HsB RDS Permit Modification Application

MR RESPONSES to DEQ

Horseshoe Bend (HsB) Rock Disposal Site (RDS)

Stage 1 Drainage System Report

Figure 4.1 HsB RDS Stage 1 RDS Construction Sequencing

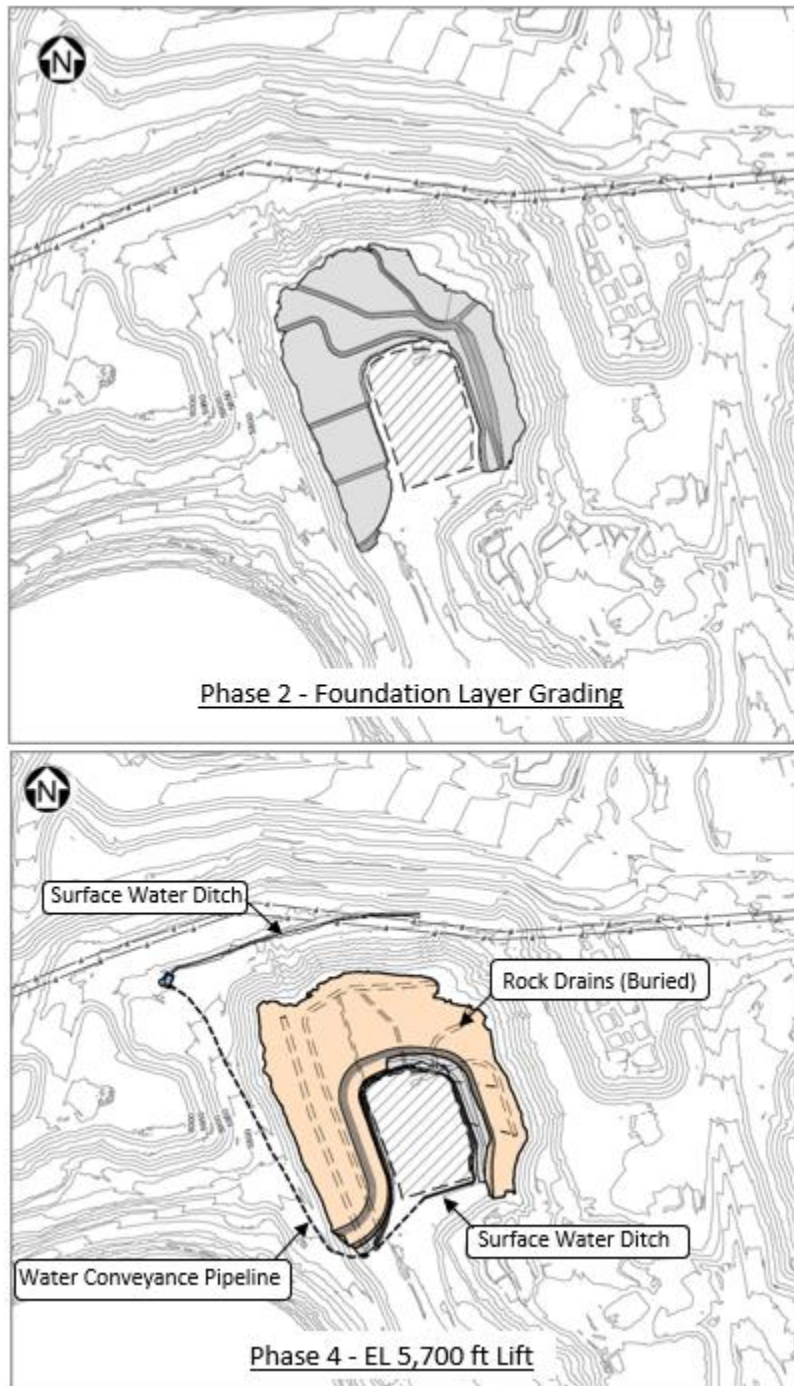
The application should include details for the RDS for the applicable stage(s). Topics should include: the ground preparation/excavation necessary to tie-in existing seeps to the drain system, the phases and timeframe to construct the RDS, the timeframe to complete reclamation, the methods for grading final slopes, placement of capping material, revegetation, and runoff control measures (see comparable features in existing Plan).

Figure 2 of the HsB RDS permit modification application shows sequencing of Stage 1; three phases of the drainage system, and 2 phases of the RDS. As discussed with DEQ at a meeting on January 14, 2022, certain activities within the Precipitation Plant exempt area may occur without DEQ approval of a permit modification. These include activities related to water management including demolition, building removal, site grading, ditch, and pipe and drain installation. Placement of non-ore rock in the 5700- and 5900-foot lifts would occur after approval of the permit modification. Phases 1 through 3, which cover the drainage system design, would begin prior to mid-October 2022 as soon as site conditions allow, and would be completed prior to placement of rockfill. Placement of rockfill would begin after the drainage system has been completed, this permit modification is approved, and as non-ore rock is available, and would continue until the 5900 lift was finished.

4.4 HORSESHOE BEND POND

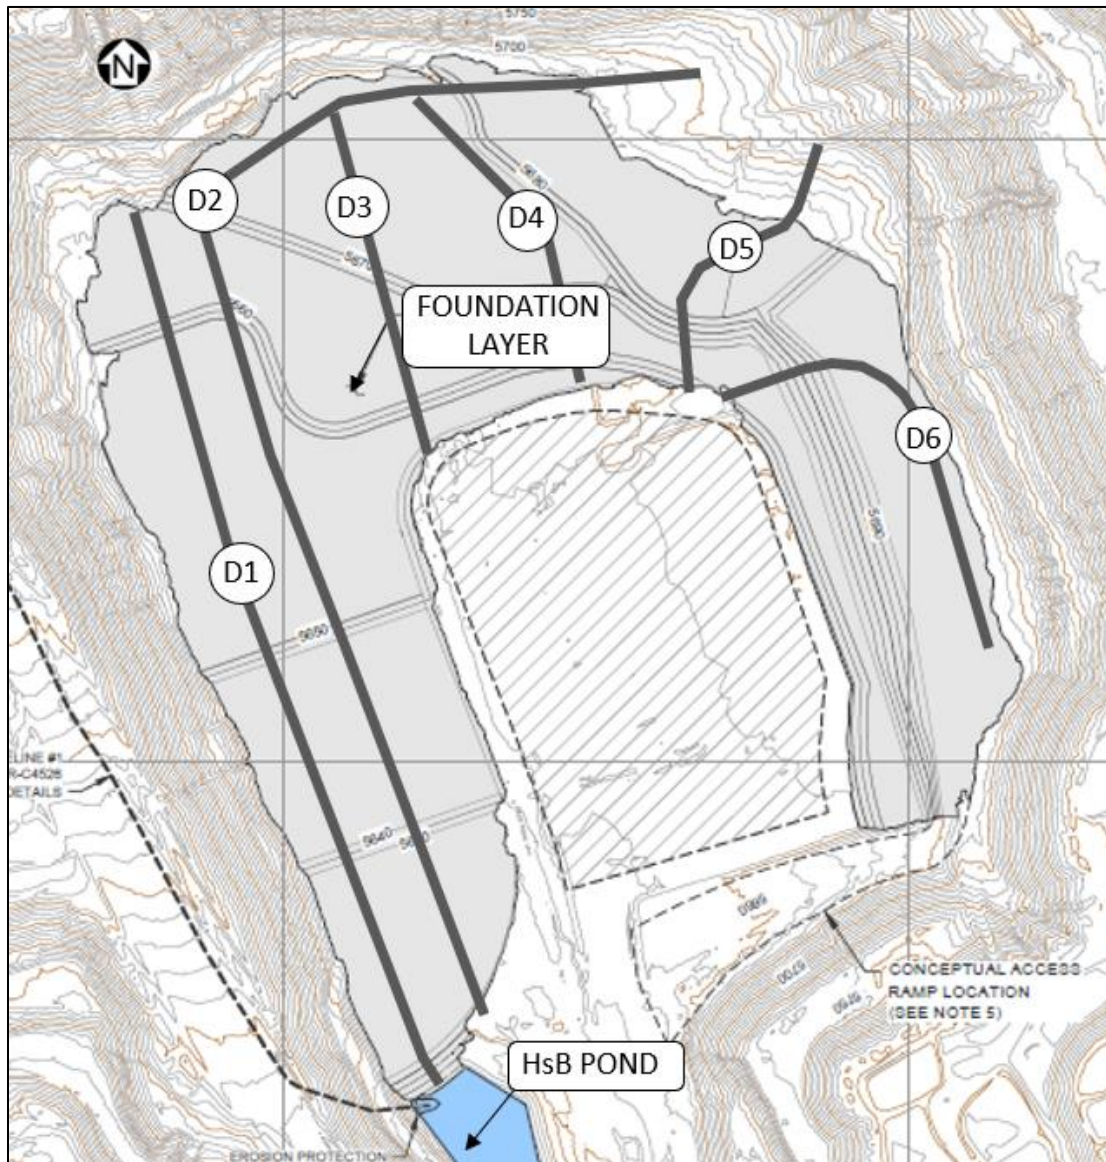
pp. 24 and 25, Section 4.4: "The drainage system discharges into the HsB Pond where flows will continue to be conveyed to the HsB Weir in a manner that limits impacts to the existing water management infrastructure. Construction of the drainage system across the upstream section of the HsB Pond will reduce the existing pond footprint area by approximately 50% to 2.8 acres. The flow length of the pond will also be reduced to approximately 1,000 ft. This size reduction will impact the ponds' ability to attenuate incoming flows and buffer peak storm events but is not expected to impact the water management systems downstream of the HsB Pond."

If the HSB Pond area and corresponding attenuation capacity will be decreased by ~50%, please further quantify and explain the capacities of the downstream water management and treatment systems. Although the design report states that impacts are "not expected," DEQ needs further details to evaluate potential impacts from large storm events and determine whether the proposed changes to HSB Pond would potentially "conflict with local, state, or federal laws, requirements, or formal plans." (17.4.608(1)(g), Montana Code Annotated, MCA)

Please also include an explanation of the potential flowpath(s) under upset or overflow conditions (e.g. the Berkeley Pit?), whether due to large storm events or changes/delays with the water treatment facility or mine operations that might affect available capacity.

The HsB ponds proposed to be filled currently offer little flow attenuation (flow equalization capacity) as the stage of these ponds is controlled by the weir at the south end of the ponds. HsB pond water will continue to flow through the weir at the south end of the pond. A diversion structure below the weir allows water to be directed to either the HsB CS or HsB WTP. Flow over the weir controls the storage capacity of these ponds and can only vary by a few inches. True flow equalization to the downstream water management systems occurs in the equalization basin in front of the HsB WTP, which would be unaltered by approval of this permit modification. During upset conditions, an overflow pipe near the diversion structure allows discharge to the Berkeley Pit. MR will consult with the EPA to ensure that there is no conflict with the BMFOU remedy.

See response to Comment 1(a). As operations currently provide, flows in excess of treatment capabilities whether due to treatment facility downtime or very high flows (which has not occurred since the construction of the HsB CS) would be directed to the Berkeley Pit through existing infrastructure. Approval of this proposed permit modification would not change bypass/overflow management currently authorized by the BMFOU remedy

DRAWING NO.	MR-C4526	REVISION	0
-------------	----------	----------	---

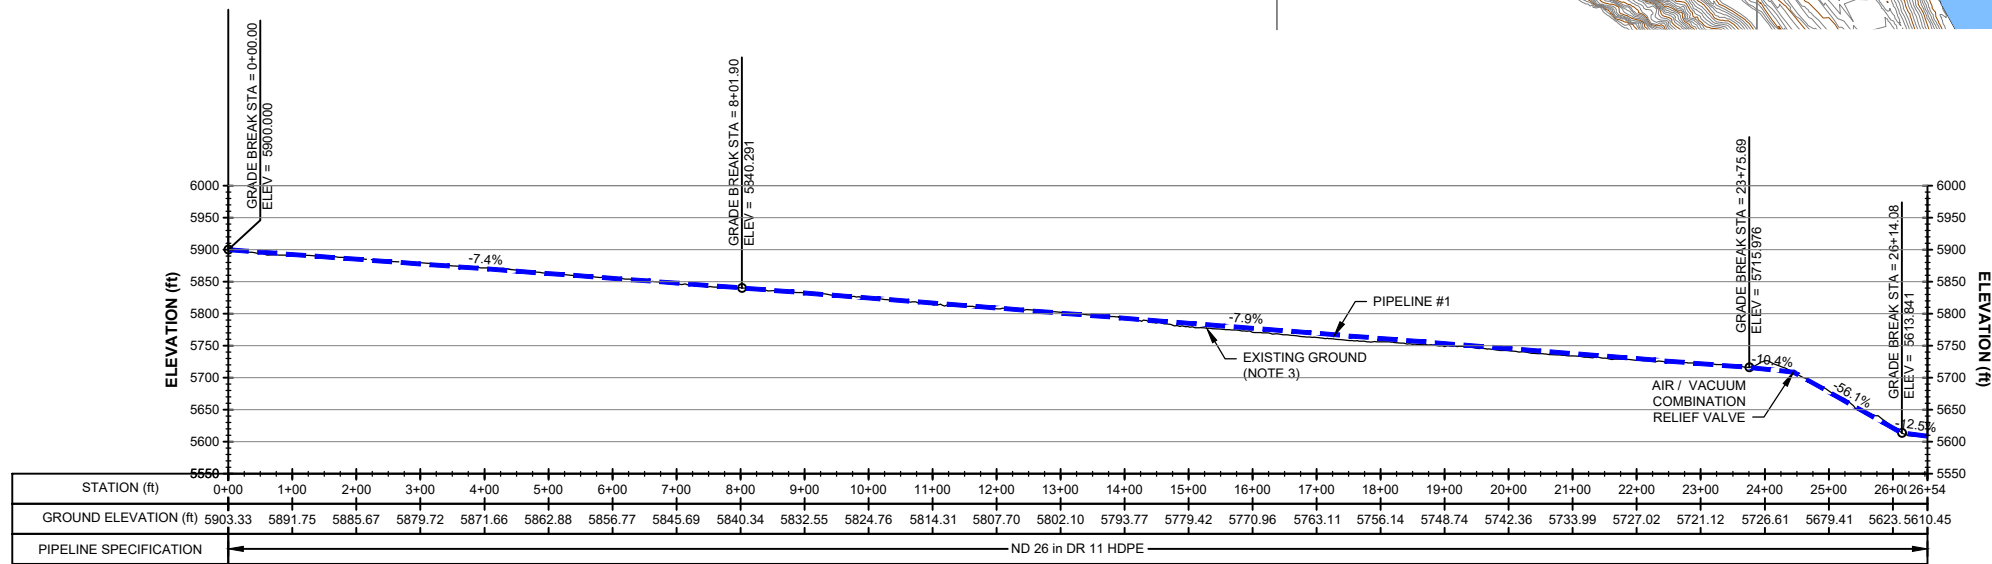
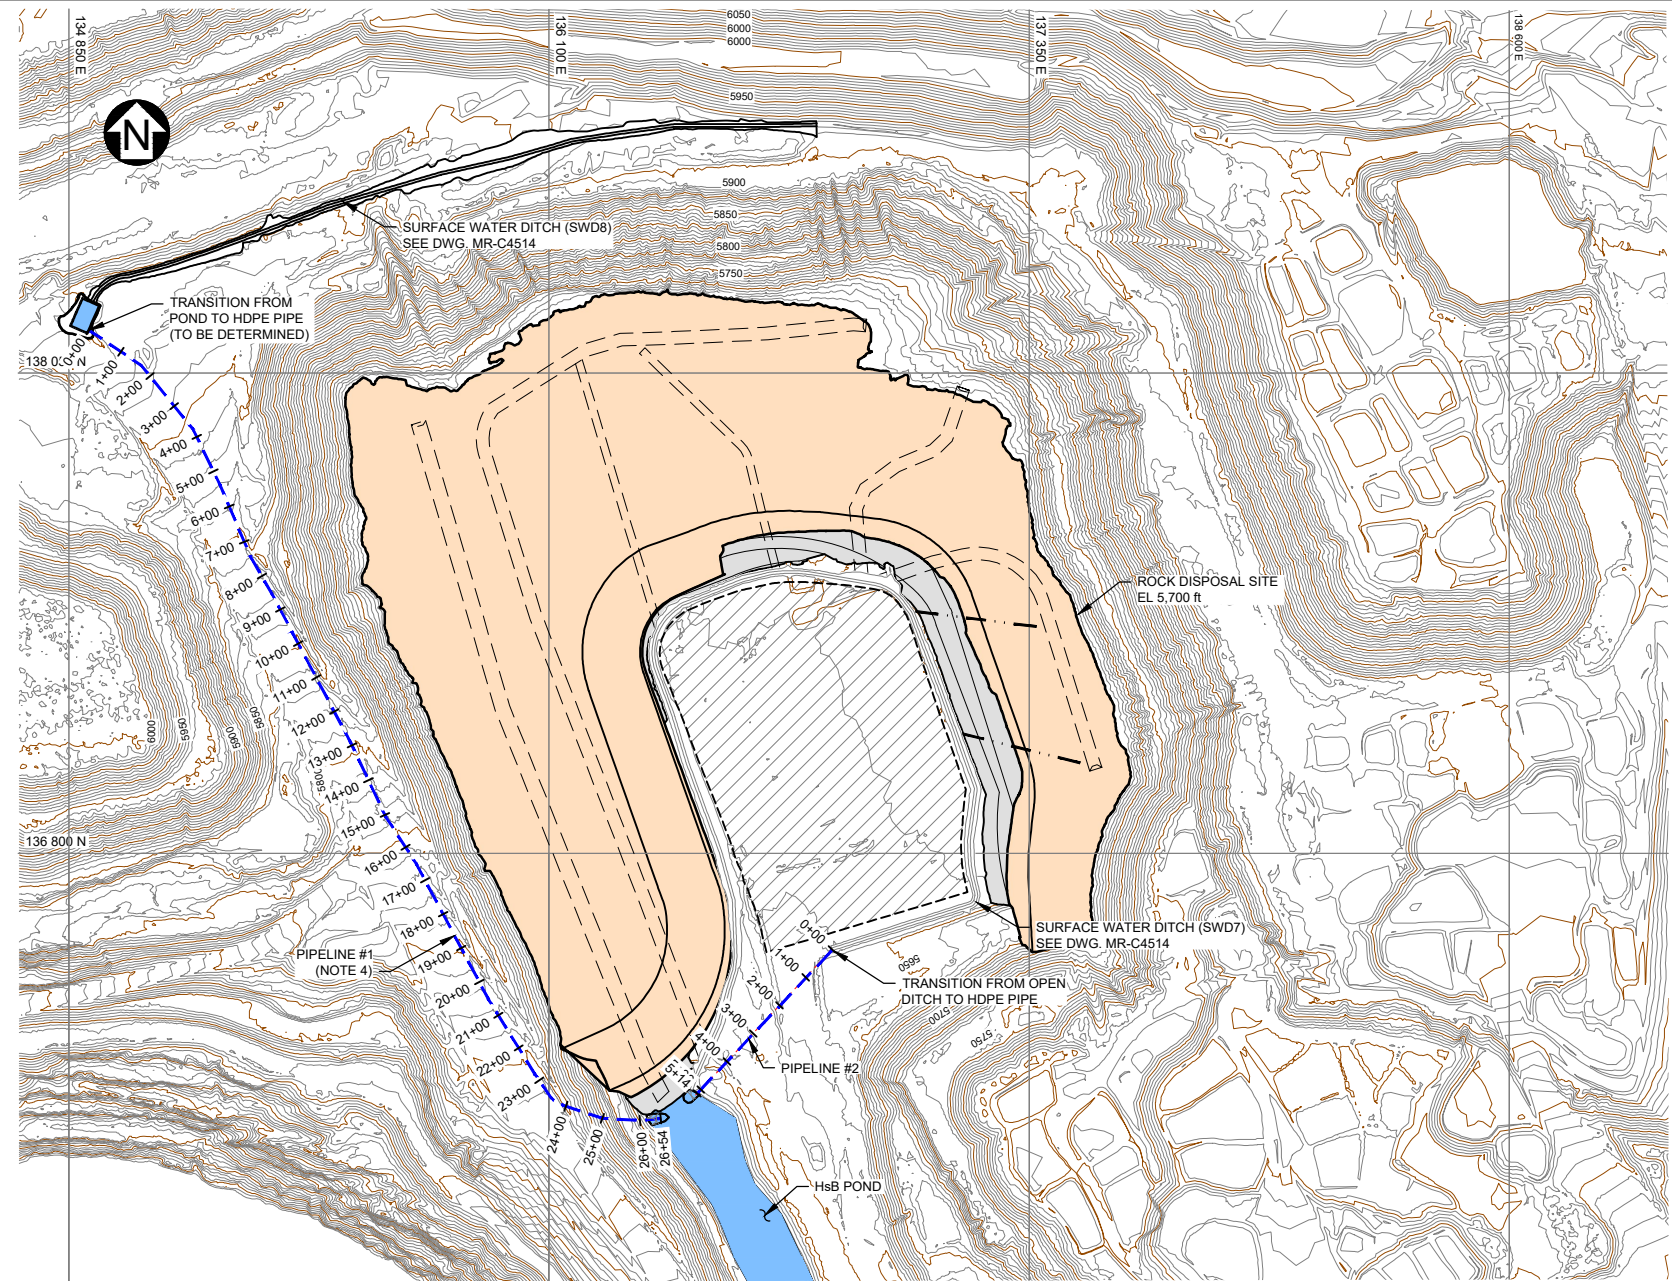
p. 37, Section 6.2: “At the western end of surface water ditch SWD8, the ditch is designed to discharge into a pipe to convey the flows down the 7% Ramp and into the HsB Pond, referred to as Pipeline #1 on Drawing MR-C4526 in Appendix A. The pipe is specified as a nominal diameter (ND) 26-inch DR11 HDPE pipe. The transition from ditch to pipe shall be made via a small surface pond or approved alternative. Surface water ditch SWD7 also transitions to pipe at its western extent beneath the existing access road, referred to as Pipeline #2. The specification for Pipeline #2 is the same as Pipeline #1 (i.e. ND26-inch DR11 HDPE).”

As part of the permit modification application, please include details about the operation and reclamation of the ditch and pipeline systems. This should include a discussion about the longevity and maintenance/replacement schedule for the pipeline, although DEQ suggests that a pipeline may not be sufficient for long-term, post closure runoff controls.

Please include an explanation about whether the pipeline would be replaced with surface ditches for post closure water management and explain the appropriate storm event return period for sizing the long-term feature(s) (see related comments).

Similar to other pipelines in the permit area, the drainage pipeline system will be monitored during operations and maintained as necessary. After closure, the pipelines will be replaced with ditches. Reclamation of the ditches is addressed in the permit modification application and will be included in the revised Reclamation Plan for the mine. See also response to Comment 2(b).
